APPEAL SUMMARY

Appeal ID: 16542	Project Address: 5959 SE 92nd Ave
Hearing Date: 2/28/18	Appellant Name: Masaye Hoshide
Case No.: M-005	Appellant Phone: 503 892 7104
Appeal Type: Mechanical	Plans Examiner/Inspector: Thomas Ng
Project Type: commercial	Stories: 5 Occupancy: R-2, A-3, A-2, S Construction Type: V-A, I-A
Building/Business Name: Oliver Station	Fire Sprinklers: Yes - fully sprinklered
Appeal Involves: Erection of a new structure	LUR or Permit Application No.: 16-219971-CO
Plan Submitted Option: pdf [File 1] [File 2] [File 3]	Proposed use: Affordable Housing

16-219971: OLIVER STATION WEST BLOCK

EXHIBIT C: ENLARGED ELEVATION SHOWING MUFFLER LOCATION

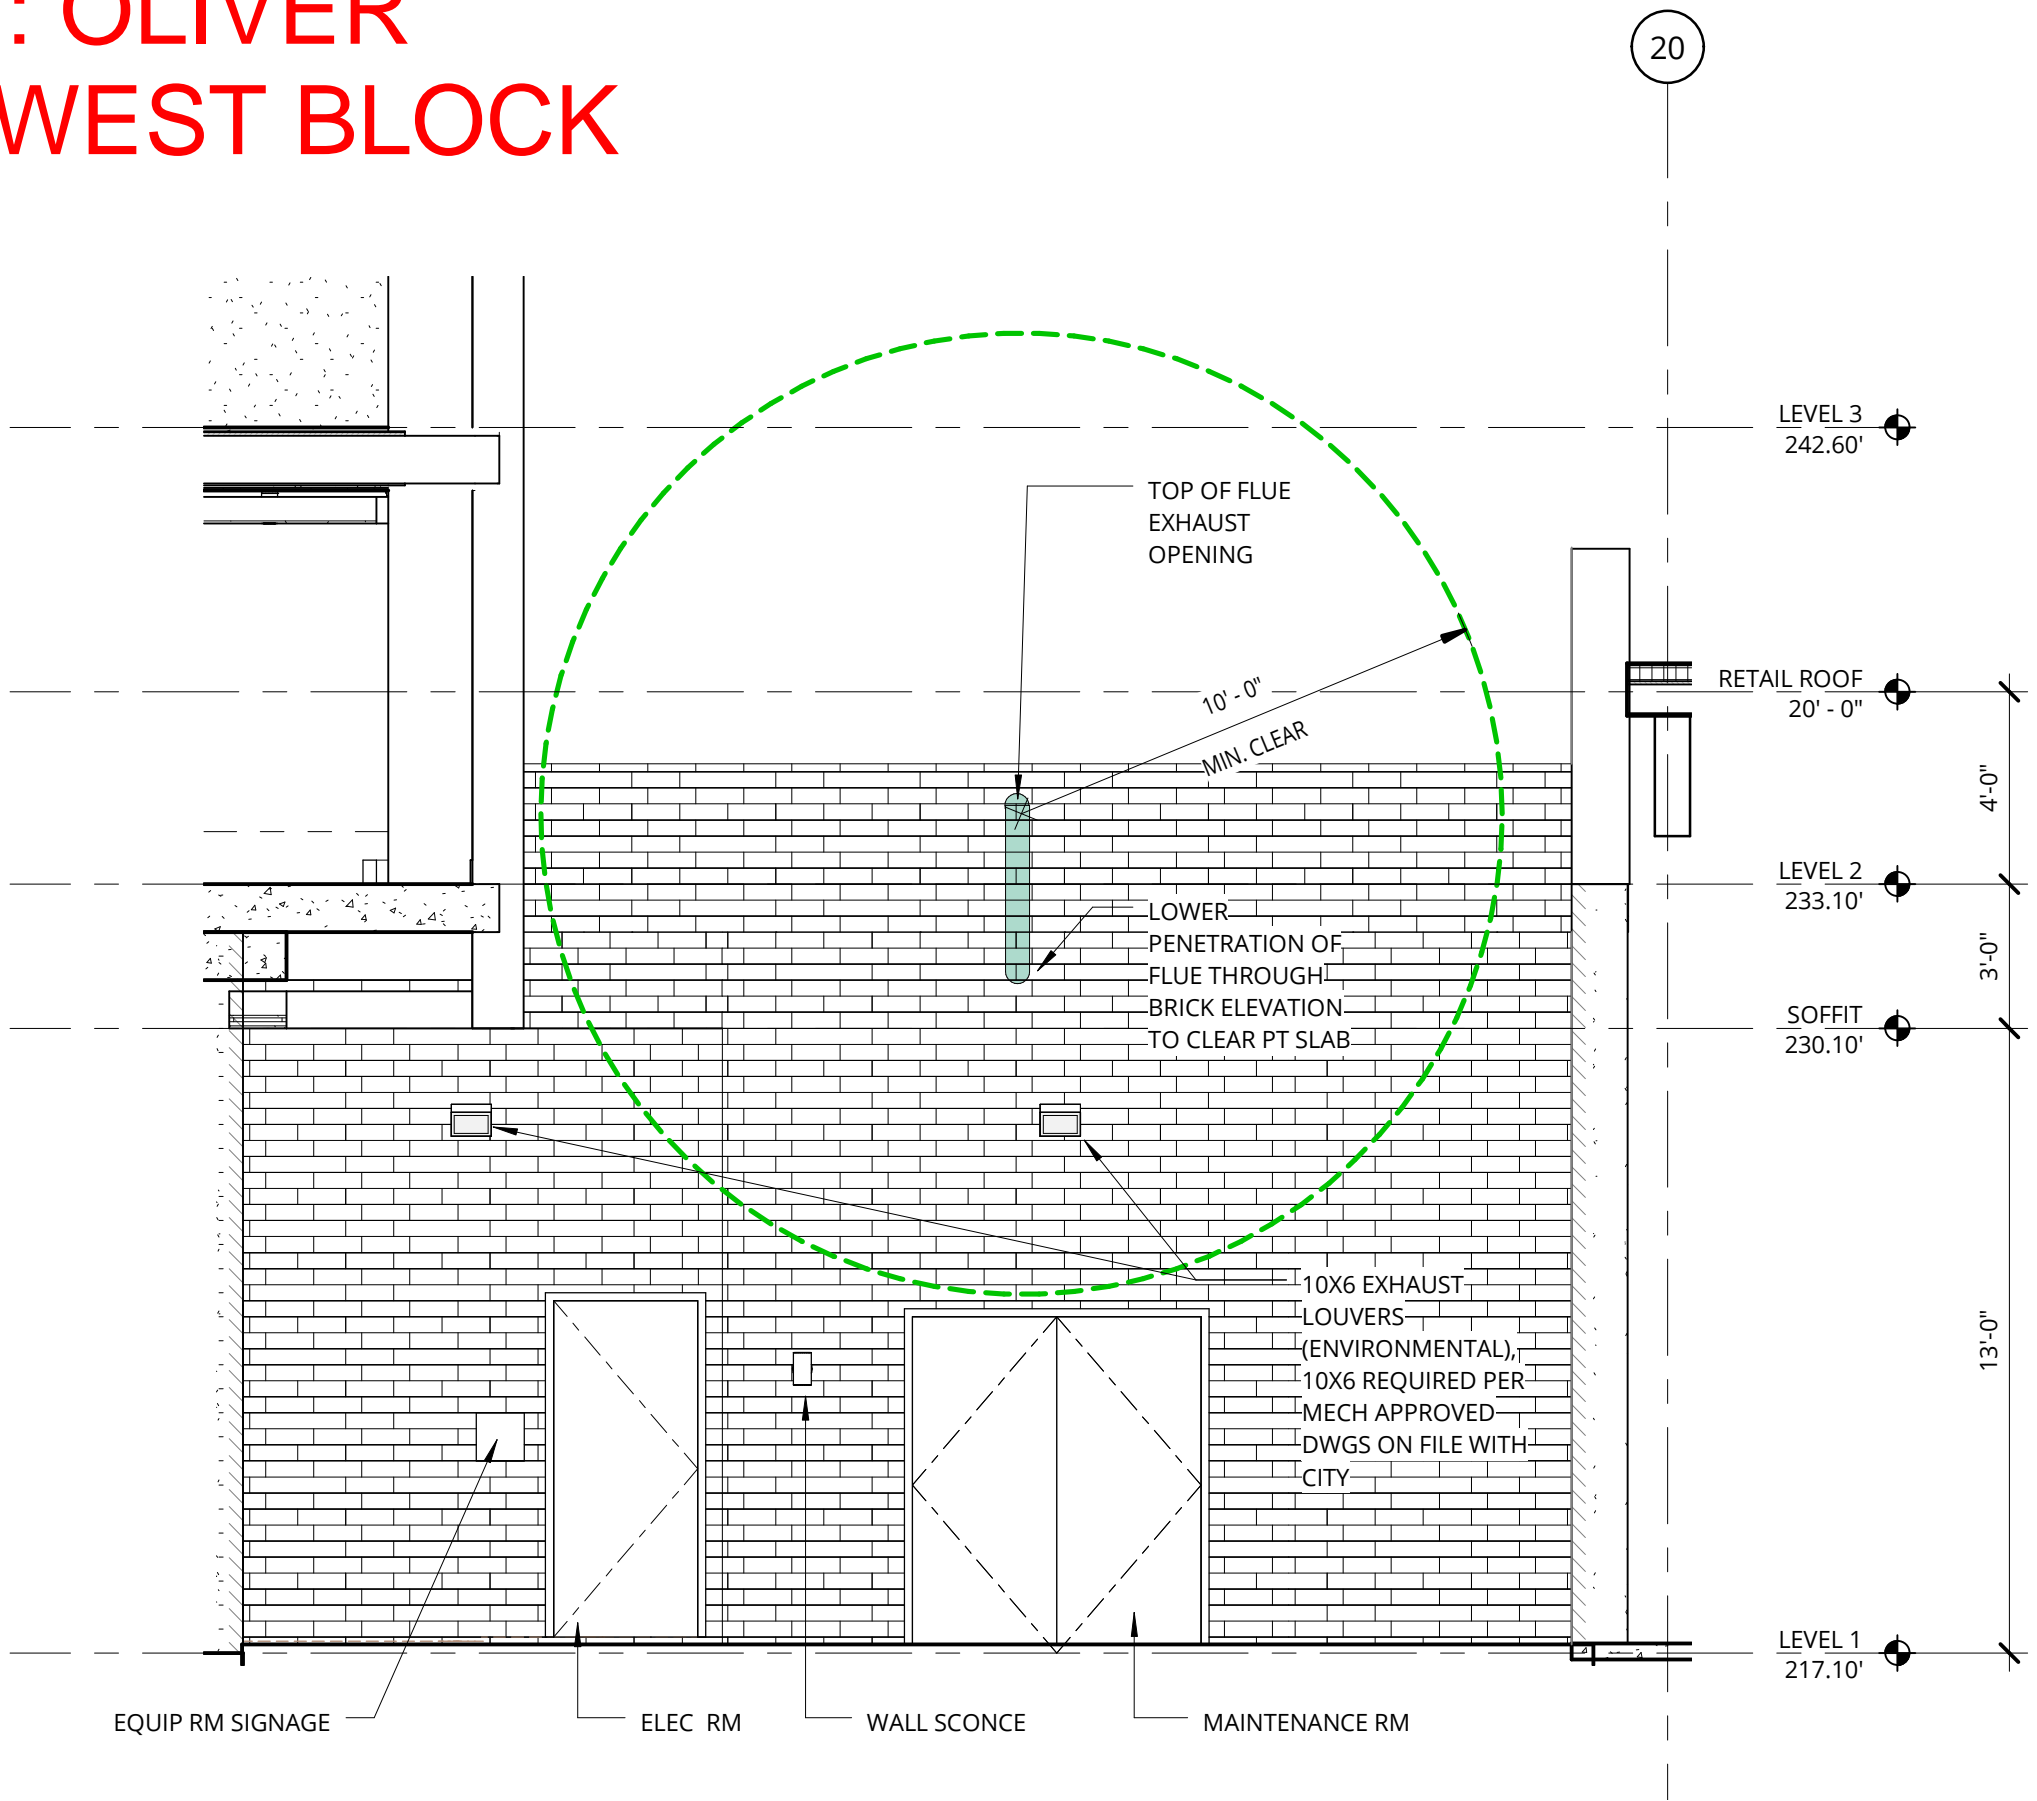
We believe it is incorrect to define exhaust louvers exhausting environmental air as operable openings into buildings. Exhaust louvers function to exhaust air away from buildings. While the generator 3" muffler flue runs intermittently to either test the emergency equipment or during actual emergency operation, the adjacent exhaust louvers will be exhausting environmental air away from the building making it physically impossible for flue exhaust to travel back into the building via the exhaust louvers. Exhaust louvers should not be defined as operable openings into buildings. See attached building plans and elevations which demonstrate compliance of the location of the 3" generator muffler per 2014 Oregon Mechanical Specialty Code; 503.1.1, 2, Location of Exhaust Outlets

Exhaust vent within 10 feet of operable opening: Hold for additional information.
Appellant may contact Thomas Ng (503 823-7434) with questions.
